8.1 **DA 2010/962 - Highway Service Centre - Section 96 Amendment**

Applicant	Sj Connelly CCP Pty Limited (on behalf of Ballina HSC Pty Ltd)
Property	Lot 11 DP 1011575 River Street (Old Pacific Highway) West Ballina
Proposal	Application under Section 96 (1A) of the EP&A Act to Modify Development Consent DA 2010/962 – Highway Service Centre
Effect of Planning Instrument	The land is zoned part RU2 under the provisions of the Ballina LEP 2012 and part 2(a) Living Area Zone under the provisions of the Ballina LEP 1987

RE: WEST BALLINA FLOOD RELIEF OPTIMISATION STUDY

Figure 2 Peak discharge for various culvert cell and floodway invert combinations (100 year ARI local catchment event)

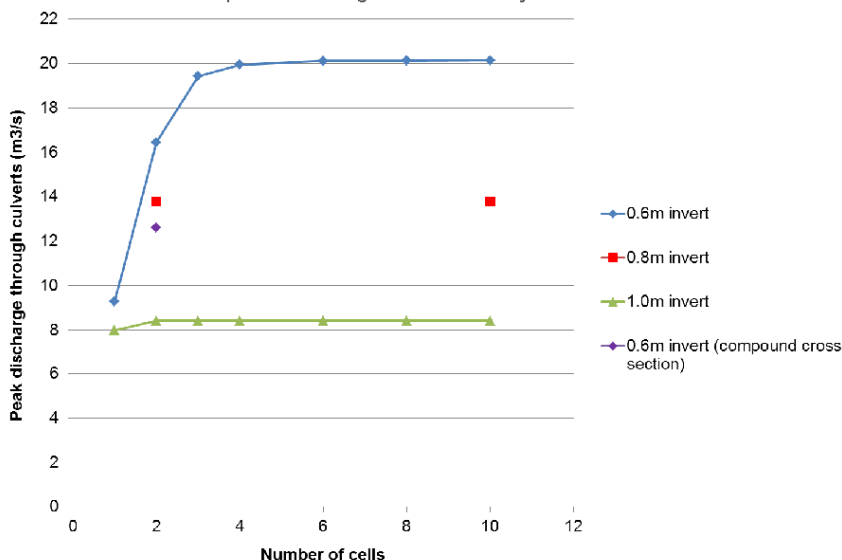
The results presented in Figure 2 indicate that for the 0.6m AHD floodway invert scenario, more than four culvert cells does not provide any significant improvement to peak discharge rates. The volumetric discharge is, however, greater with the larger number of cells due to high early discharge associated with wider culverts. This results in marginally lower peak flood levels and shorter inundation duration with more cells. The inundation duration has not been quantified as part of this optimisation study, however, will be undertaken as part of the future expansion of the culverts.

For a 1.0m AHD floodway invert, there is little difference in peak discharge rates above when more than 2 cells are used. Again, the volumetric discharge will be marginally greater with more than 2 cells.

The reason for the minimal improvement above a certain number of cells is that the floodway becomes the hydraulic control (i.e. flow is restricted by the capacity of the floodway, not the culverts). The results of this assessment highlight the sensitivity of the floodway invert. By reducing the floodway invert from 1.0m to 0.6m AHD, the discharge through the West Ballina Flood Relief more than doubles. This is evident in all event sources (Richmond River and local catchment) and event magnitudes (20 year and 100 year ARI) that have been assessed.
